**Freightliner
Service Bulletin**

Powernet Distribution Box (PNDB) Replacement

Fig. 1, Powernet Distribution Box (PNDB)

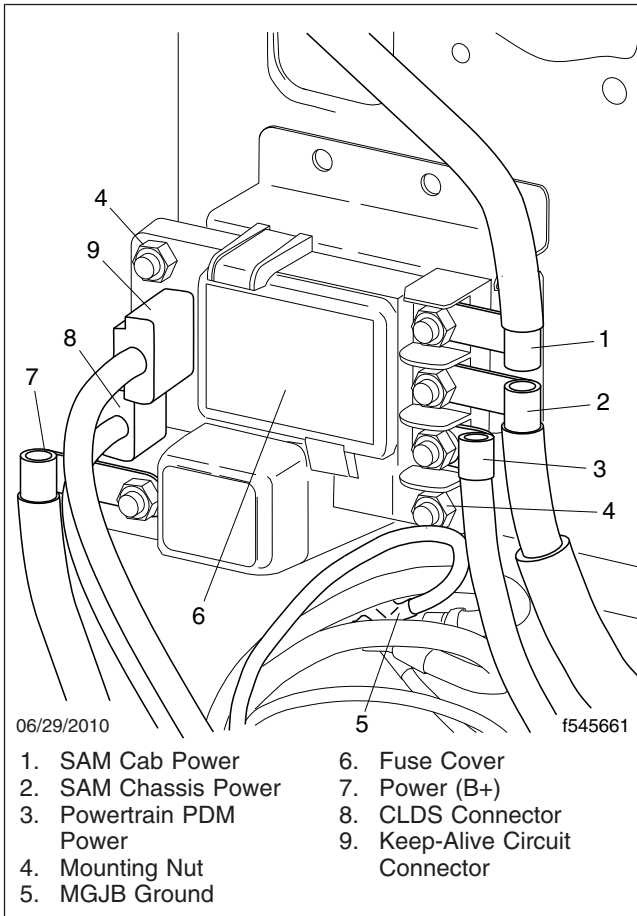
NOTE: The powernet distribution box (PNDB) is located on the cab frontwall, above the main ground junction block. See [Fig. 1](#).

Fig. 2, Removing the Circuit Connector

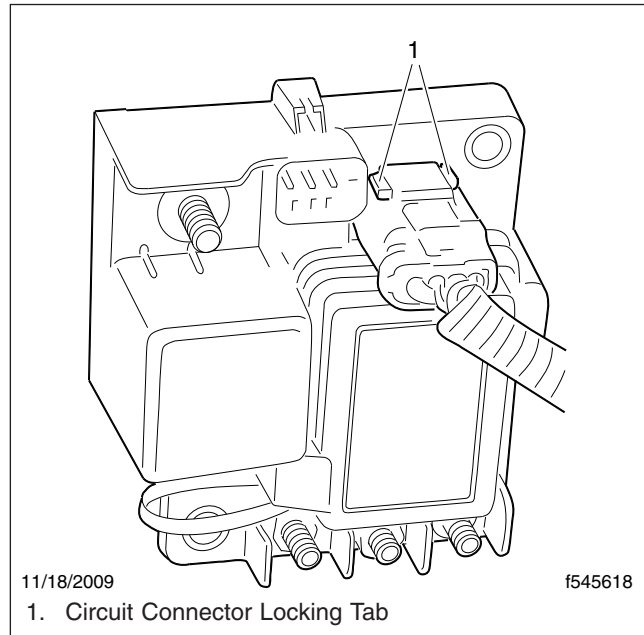
5. Disconnect the keep-alive circuit connector from the PNDB.
 - 5.1 Using a flat-head screwdriver, push the red locking tab up.
 - 5.2 Press and release the tab, then remove the connector. See **Fig. 2**.
